ENVIRONMENTAL & NATURAL RESOURCES COMMISSION STAFF REPORT
Meeting Date November 30, 2022

AGENDA ITEM: Wetland Buffer Variance, Enclave Apartments, 3090 Southlawn Drive

Westwood Professional Services, Inc., received the review comments via email from the City of Maplewood on 11/07/2022 regarding the Landscape Plan dated 10/24/2022 and the Tree Preservation Plan submitted 09/28/2022 for Maplewood Enclave Apartments. We have addressed these comments. In red below are our responses.

PREPARED FOR: **MAPLEWOOD ENCLAVE DEVELOPMENT**
 300 S. 33RD AVE. E. SUITE 300
 WEST FARGO, ND 58078
 DATE: 11/11/2022 REVISED: 44018
 PROJECT NUMBER: 0037066.00
 SHEET NUMBER: **L100**
 MAPLEWOOD ENCLAVE

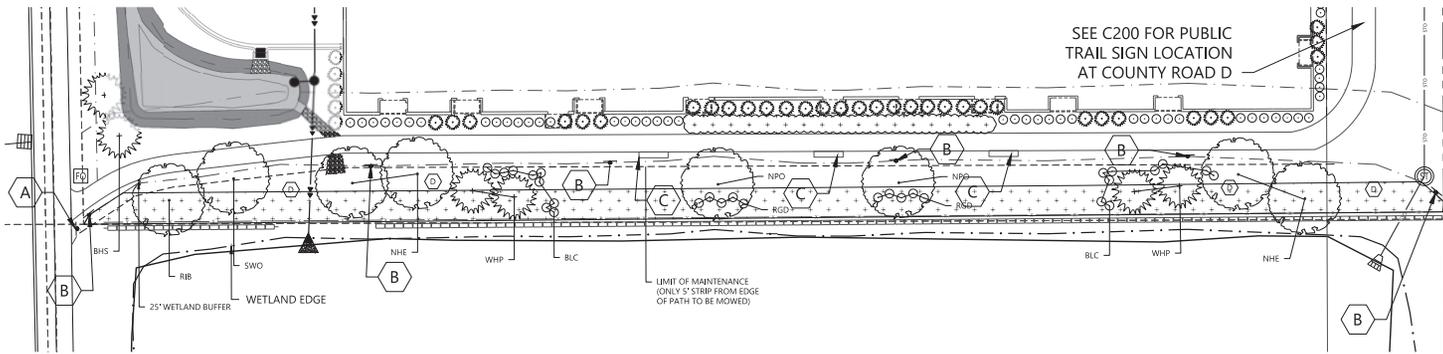
3. Tree Replacement: The landscape plan shows 42 new trees, totaling 105 caliper inches of replacement trees. This is 61 caliper inches less than City code requires. *RESPONSE: Noted, updated landscape plan shows a deficiency of 46 caliper inches. Payment to tree fund of \$2,760 will be made. See Sheet L100*

- 4) Revised Landscape Plan: The revised plan must identify 105 caliper inches of additional tree replacement. Alternatively, the applicant must pay into the **City's tree fund (see below)**. *RESPONSE: the revised landscape plan shows a 46 caliper inches deficiency, payment to City's tree fund will be made.*

- 5) Tree fund: The applicants must submit a tree fund payment in the amount of \$60 per caliper inch of replacement tree that cannot be planted on site. Since 105 caliper inches of trees are proposed to be planted on the site, the **applicants would owe the City's tree fund \$3,660 (166.2 caliper inches of required tree replacement – 105 caliper inches of trees planted on the site = 61 caliper inches of trees not planted on the site x \$60 = \$3,660)**. *RESPONSE: Payment of \$2,760 to be made to tree fund (46 caliper inches deficiency x \$60= \$2,760)*

3. Tree Replacement: The landscape plan shows 42 new trees, totaling 109 caliper inches of replacement trees. This is 48.8 caliper inches less than City code requires.

4. Tree Recommendations:
 - a. Prior to issuance of a grading permit, the applicant must submit the following:
 - 1) Revised Landscape Plan: The revised plan should show an additional 48.8 caliper inches of replacement trees. Alternatively, the applicant can pay into the City's tree fund (see below).

REPLACEMENT TREE REQUIREMENT:
 PER TREE PRESERVATION PLAN 157.8 CALIPER INCHES OF REPLACEMENT ARE REQUIRED.
 OVERSTORY CALIPER INCHES PROPOSED: 81 (17 x 2.5 + 42.5 + 11 x 3.5 + 38.5, 38.5 + 42.5 = 81)
 ORNAMENTAL CALIPER INCHES PROPOSED: 16 (8 x 2.0)
 CONFIFEROUS INCHES PROPOSED: 15 (6 x 2.5)
 TOTAL = 112

WETLAND BUFFER MITIGATION PLAN

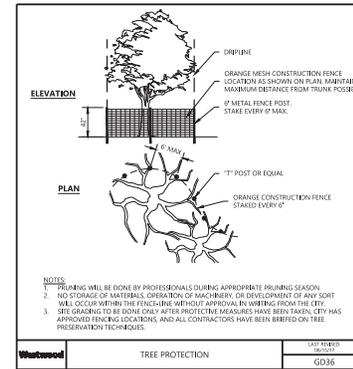
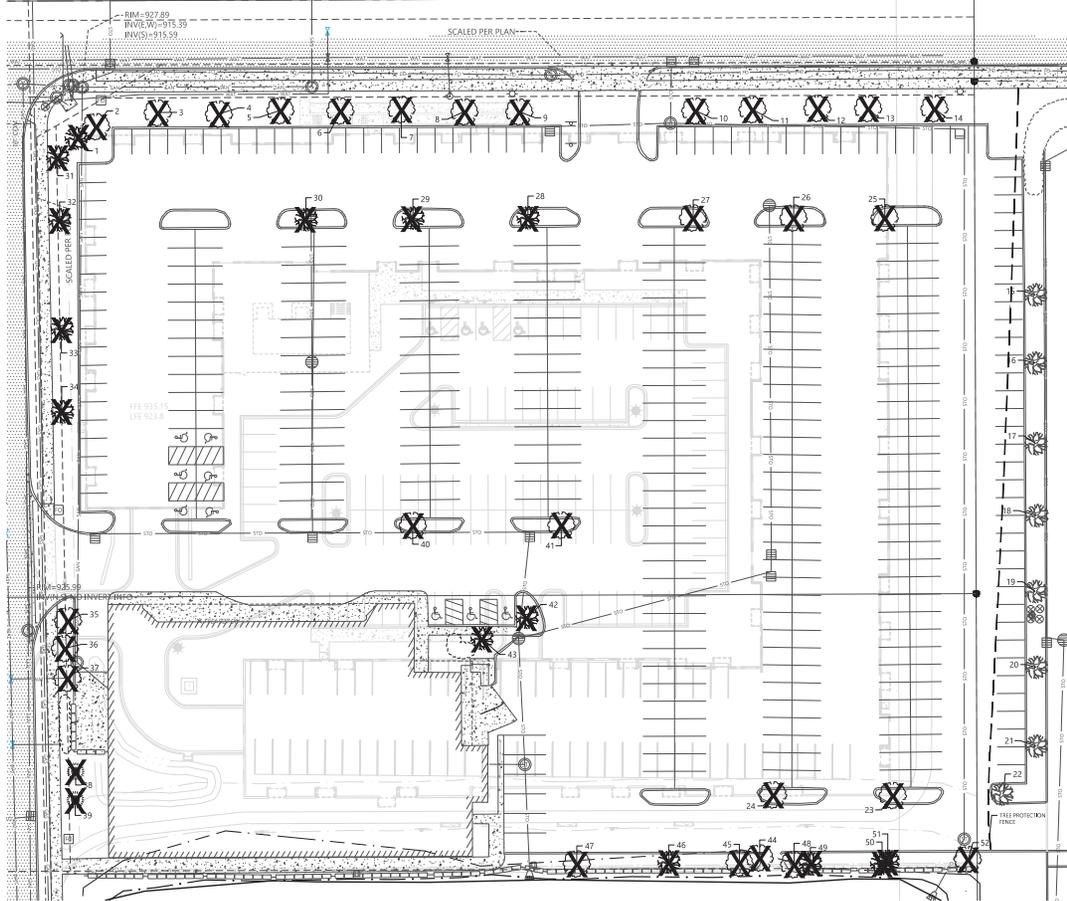
- a) **Native Plugs:** Include native plugs to be installed within the 25-foot re-established wetland buffer. Currently the landscape plan identifies a pollinator seed mix. Using plants rather than seeds hastens establishment and provides a better chance of successful establishment. The applicants should plant all plugs, or a mix of plugs and native seed mix in this area. *RESPONSE: The first 10' of the wetland buffer (the 10' closest to the wetland) will be planted with a mix of plugs and overseeding to assist in quick establishment and reduce erosion. The remaining portions to be seeded.*

- b) **Seed Mix:**
 1. Provide information on the percentages and species of native seed mix. *RESPONSE: See sheet L102 Wetland Buffer Mitigation Plan for the seed mix data sheet.*

2. Provide information on the maintenance required for the planting year, and years two and three, addressing what maintenance activities will be required and what entity (developer, owner, etc.) will take on

- c) Wetland Buffer Signs: Identify on the wetland buffer mitigation plan the location of wetland buffer signs. The City of Maplewood supplies wetland buffer signs identifying that no building, mowing, or grading should take place within the buffer. There is a \$35 fee per sign. The applicant must install the signs at the newly established wetland buffer edge (25 feet). The signs should be placed every 100 feet at a minimum. *RESPONSE: Noted, locations for six wetland buffer signs are shown on revised plans.*

- d) Public Trail Sign: Identify on the plan the location of two public trail signs to be installed at the entrances to the trail (along Southlawn Drive and County Road D). The City of Maplewood supplies the public trail sign. There is a \$35 fee per sign. *RESPONSE: Noted, locations for two public trail signs are shown on revised plans.*

- e) Bench Overlook: Identify on the plan the location of a bench overlooking the wetland along the south trail. The bench will allow pedestrians on the trail an opportunity to sit and enjoy the newly established wetland buffer. In addition to the bench, the overlook could incorporate boulders, rocks, and native plants. *RESPONSE: Noted, locations for three overlook benches are shown on revised plans in addition to landscaping in the surrounding area.*

the responsibility. *RESPONSE: See sheet L102 for maintenance info. Further information to be provided at a later date.*
